PLAT COMMITTEE July 10, 2024

Case Number: 2024-PLT-041

**Request:** Approval of a Subdivision Plat, to be known as 50 North Tibbs Subdivision,

subdividing 12.92 acres into two lots and two blocks.

#### **Preliminary Plat**

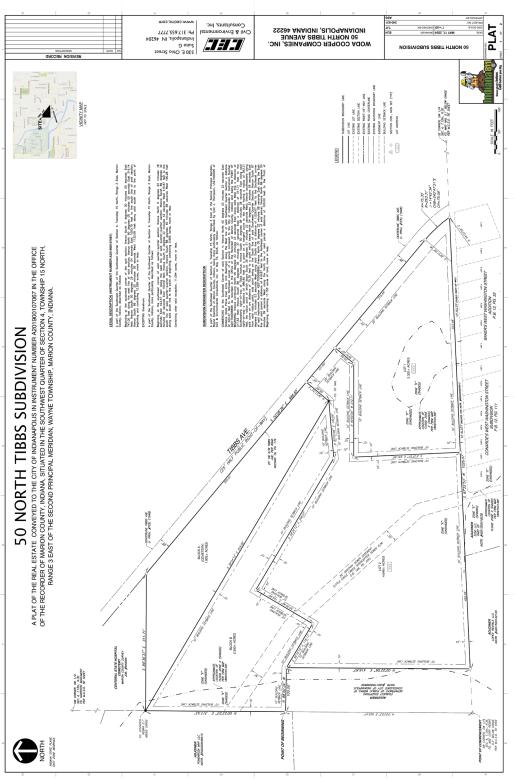
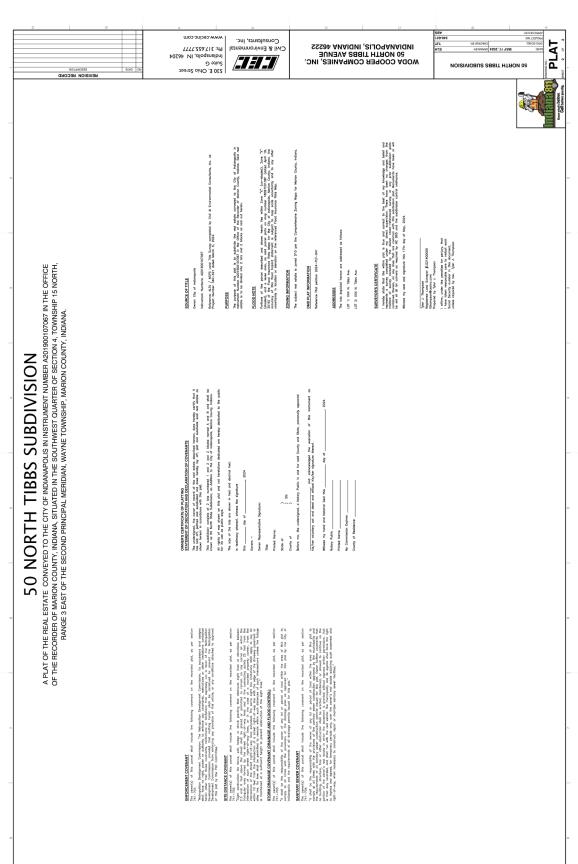
The subject site is zoned D-P / D-10 (FF) and is vacant. This proposed plat would divide this property into two lots- Lots 1 and 2, and into two blocks- Blocks A and B. Block A would be an existing cemetery and a small portion of it is zoned D-P. The proposed plat generally meets the standards of the D-10 zoning classification.

Lots 1 and 2, and Block A would front on North Tibbs Avenue, while Block B would not have frontage along North Tibbs Avenue. When these blocks are platted, all lots will require public street frontage or a variance. No new streets are proposed.

Staff recommends that the Plat Committee **approve** and find that the plat, file-dated June 10, 2024, complies with the standards of the Subdivision regulations, subject to the following conditions:
